(Joe Bedmash)

22 Mill/2cm
SANFORD NC
27332

11/7/2020

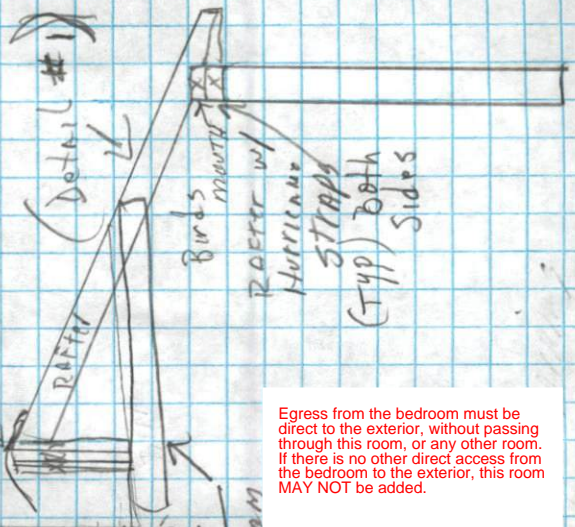
Egress from the bedroom must be direct to the exterior, without passing through this room, or any other room. If there is no other direct access from the bedroom to the exterior, this room MAY NOT be added.

#2 There is a door where the window was. IN the Bedroom
